SITING AND GRADING PLAN

Royal Pine Homes / Centerfield Properties Inc - 216102
"OAKRIDGE MEADOWS", RICHMOND HILL, ON

Lot / Page Number
BLOCK 58

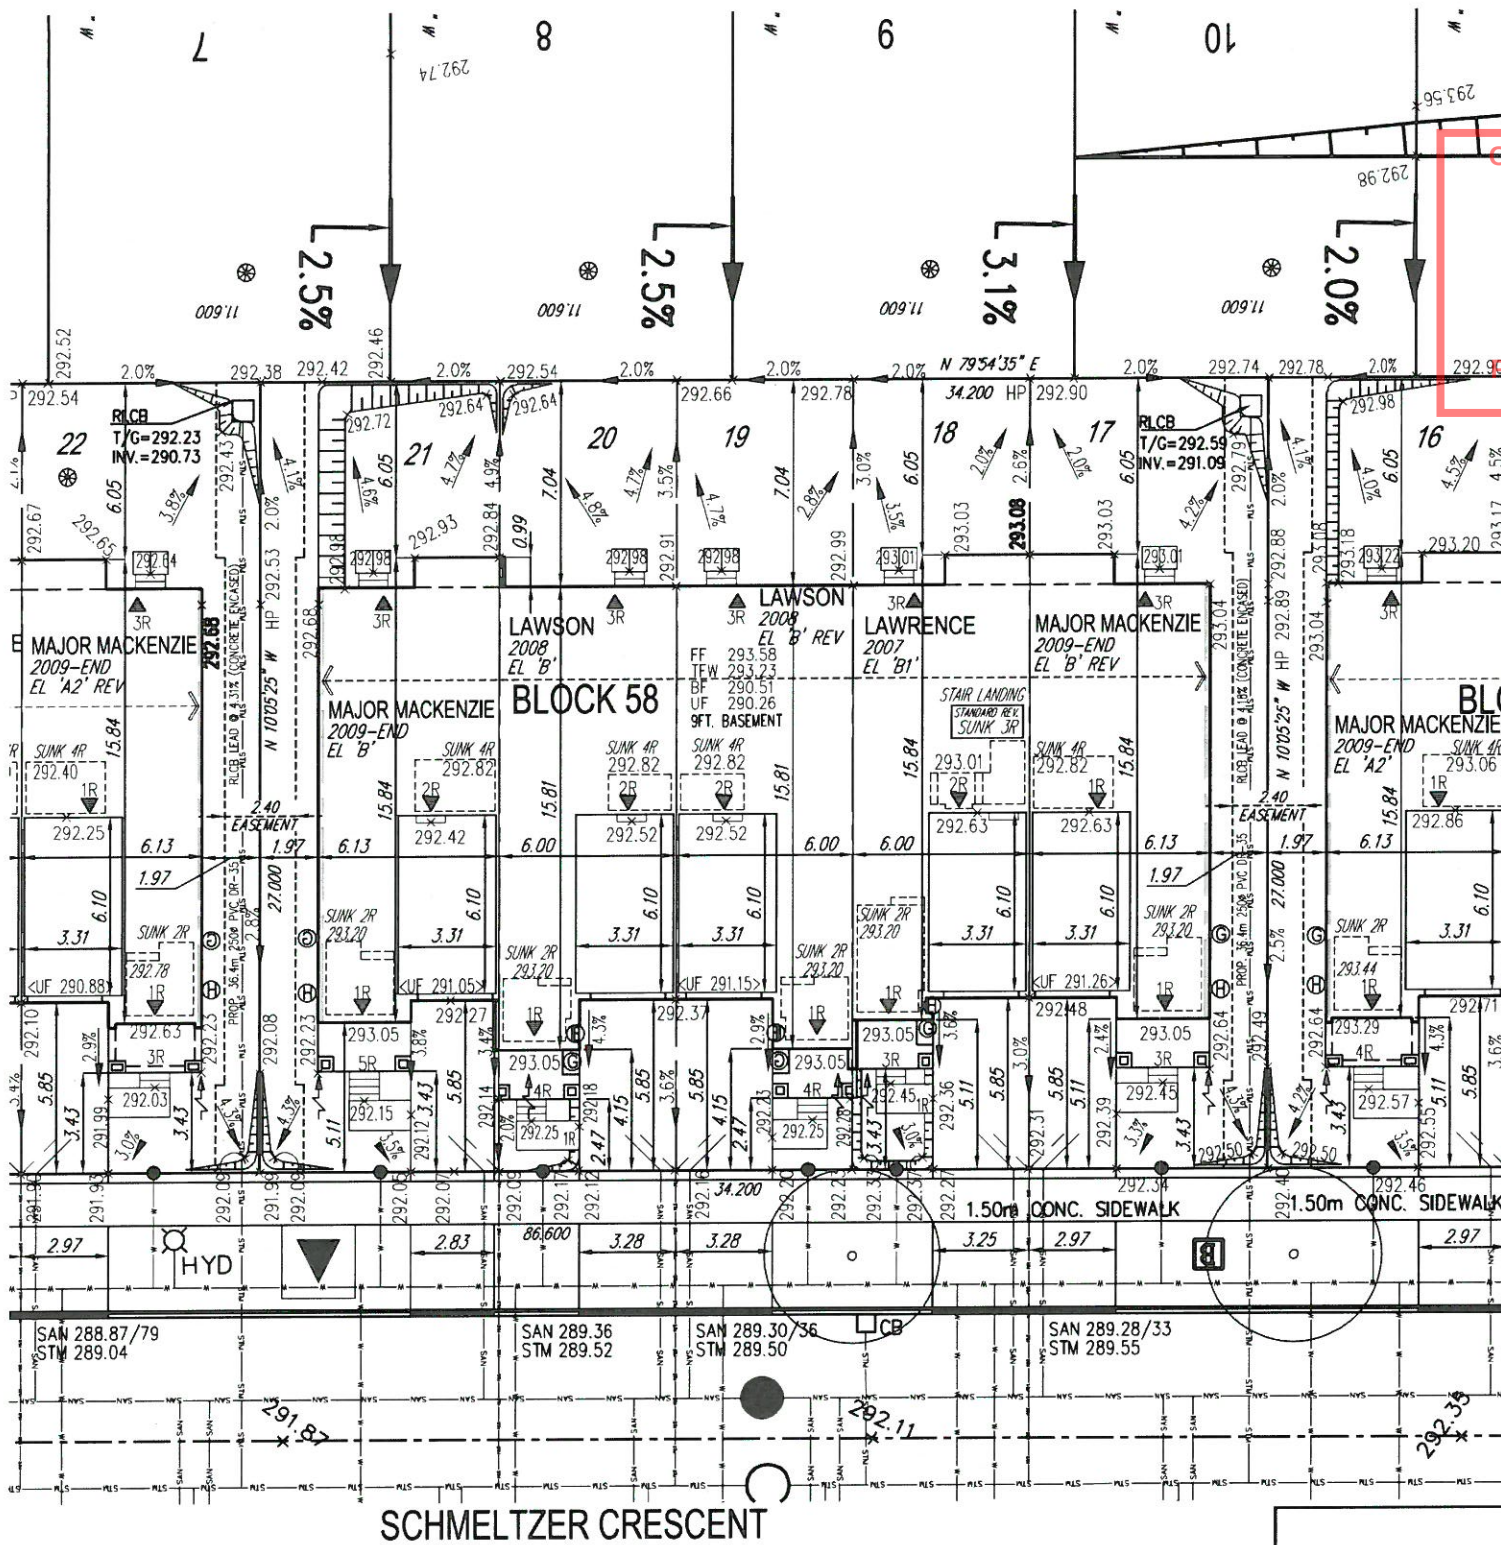
No unprotected openings permitted within 1.2 meters of the lot line as per article 9.10.14 of the Ontario Building Code.

As per OBC 2012, Div.B, 9.10.14.5(5), projections such as balconies, eaves, stairs, etc., that are more than 1m above grade, shall be non-combustible when within 1.2m of a property line or 2.4m of a combustible projection on another building on the same property.
